TR010063 Factors to be considered as to how the application should be dealt with by the ExA from ref.no: 20047638.

Your REF: TR010063
IP REF: 20047638

WEST CHELTENHAM, Joint Core Strategy Strategic Allocations A11

Site location plan attached - End

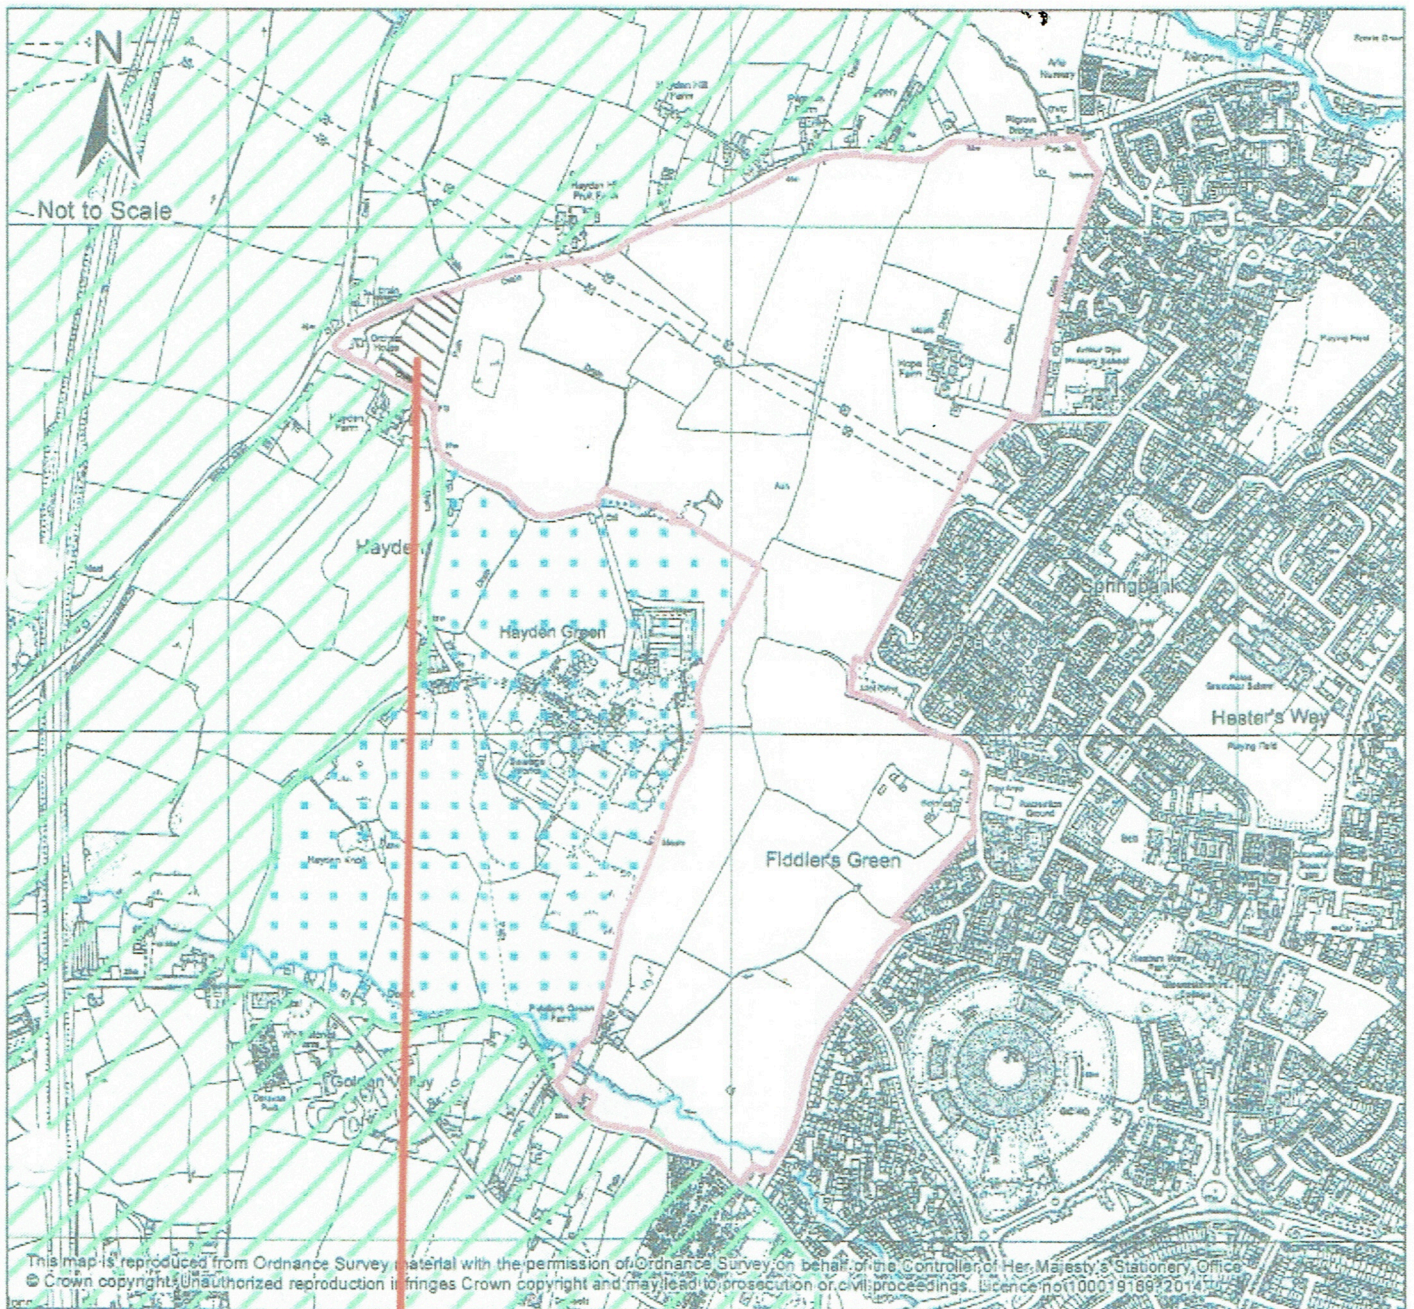
- 1) Neighbouring land / property owners should be made aware of the impact surface water and water from Hayden Sewage Treatment works will have along open water courses around Hayden Lane, along the side of my field as per attached plan, under the B4634, and along ditches leading to the river Chelt.
